Access Compliance Report Public Rights-of-Way (Curb Ramps)

Main Street: AURA_LN Cross Street: N/A Location: SE

ADA ID: RPRK211028123122 Ramp Type: Type 4 - Parallel Initial Pass/Fail: Fail Overall Compliance: No Severity Score: 15

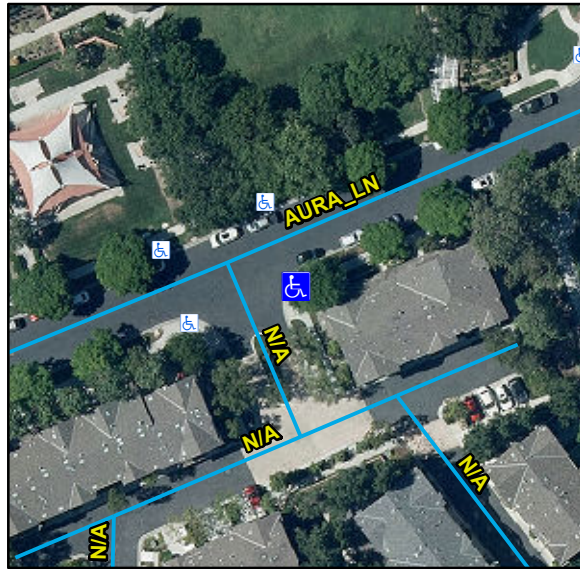
Compliance	Description	Data	Compliance	Description	Data
N/A	Ramp Length LT (in)	123	N/A	Ramp Length RT (in)	122
Yes	Ramp Width LT (in)	89	Yes	Ramp Width RT (in)	90
No	Ramp Run Slope LT (%)	11.8	Yes	Ramp Run Slope RT (%)	0.3
Yes	Ramp Cross Slope LT (%)	1.3	Yes	Ramp Cross Slope RT (%)	0.3
N/A	Landing Present	N/A	N/A	DWS Provided	N/A
N/A	Landing Length (in)	N/A	N/A	DWS Contrast	N/A
N/A	Landing Width (in)	N/A	N/A	DWS Length (in)	N/A
N/A	Landing Run Slope (%)	N/A	N/A	DWS Full Width	N/A
N/A	Landing Cross Slope (%)	N/A		DWS Offset Type	N/A
N/A	Landing Movement Obstructed?	N/A	N/A	DWS Offset Left (in)	N/A
	Landing Movement Type	N/A	N/A	DWS Offset Right (in)	N/A
N/A	Landing Shared	N/A			
N/A	Clear Space	Yes			
N/A	Clear Space To Crosswalk (in)	N/A			
N/A	Marked Crosswalk 1	No	N/A	Marked Crosswalk 2	No
	Crossing 1 Direction	N		Crossing 2 Direction	W
	Marked Crosswalk 1 Width (in)	N/A		Marked Crosswalk 2 Width (in)	N/A

Remove & Replace Curb Ramp With Two New Directional Ramps or Equivalent.
